Subcontract #:
 Change Order #: #009 Bulletin#7 - Rev.1
 Date: 5/5/2026
 Project: West Lafayette, IN - Hub Chauncey

Blake Solutions, Inc. is submitting a Request for Change Order for the following changes

#498 Upgrade Unit Bathroom - Side Splash For Record

PCI-0053 - AMS FP COR #015

5 MANSION UPGRADE BATHROOM - VANITY ELEVATION FINISH
1/2" = 1'-0"

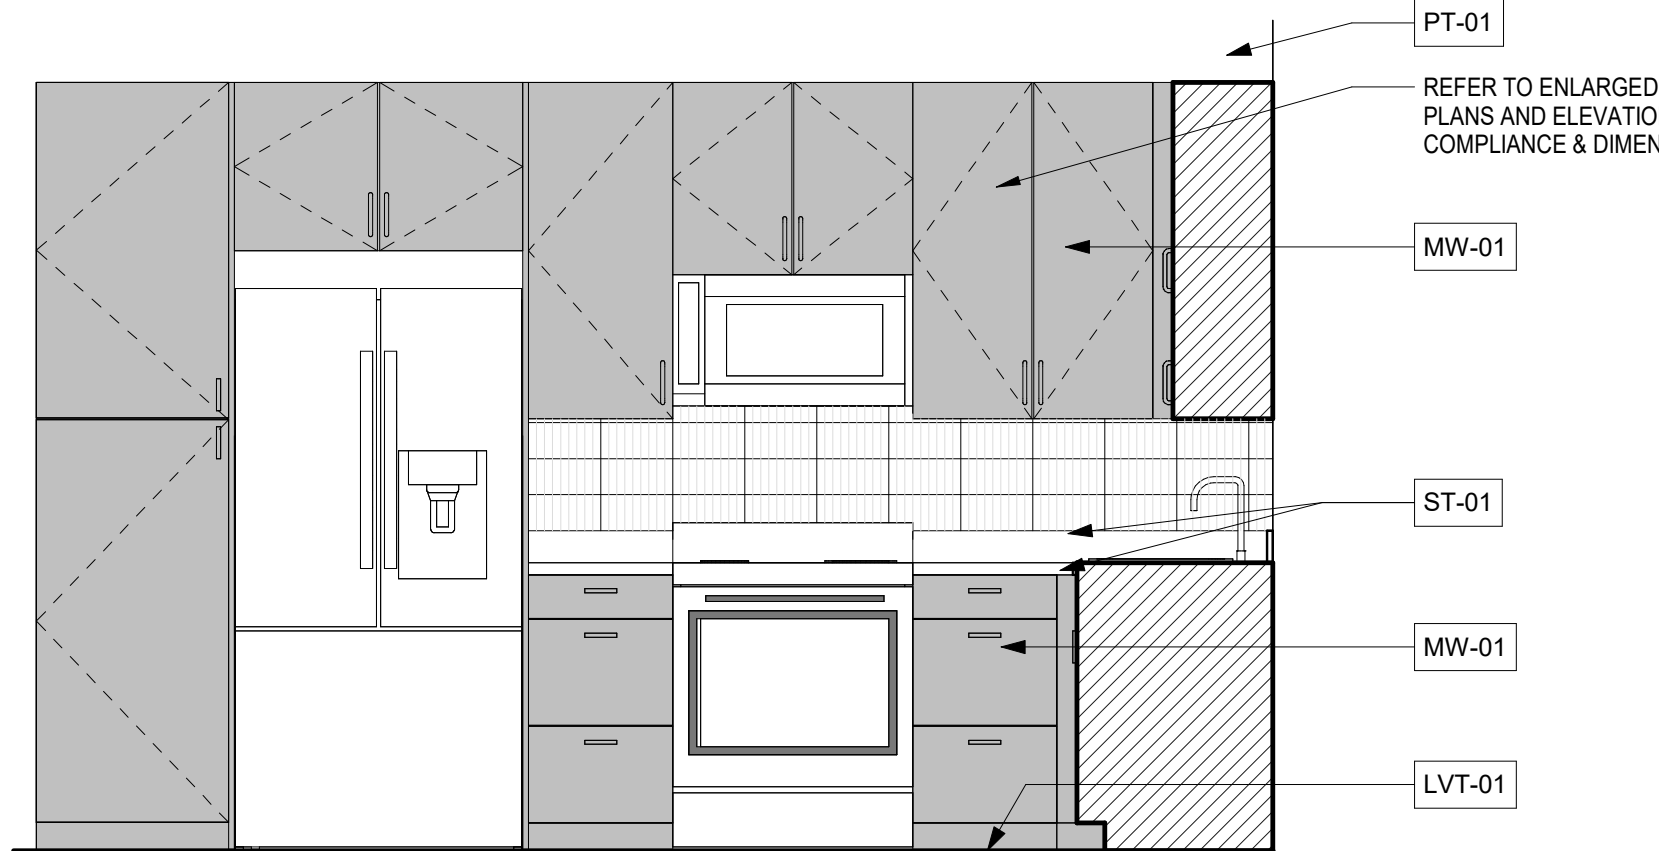
Per email conversation on 11/14: All upgraded bathrooms should continue tile work for the sidesplash of the countertops. The height must remain consistent around the sides of the vanity as shown in the reference picture below, and should never exceed 3'-2" as indicated on detail 5/A5.22.

Nishith Shah (ANTUNOVICH ASSOCIATES): Upgrade unit bathrooms are to receive a quartz sidesplash and backsplash. No tile at the quartz countertop - similar to the standard units.
At the toilet there will be tile that goes up to the underside of the shelving.
See markup on detail 5/A5.22.
The architect's responses to the contractor's questions or request for information assumes this to be a clarification and within the GMP contract amount. If there are any cost changes anticipated, please inform the owner immediately per the terms of the contract.
- N Shah (Antunovich) 01/27/2026
*By **Nishith Shah** (ANTUNOVICH ASSOCIATES) - Jan 27, 2026, 10:04 AM CST*
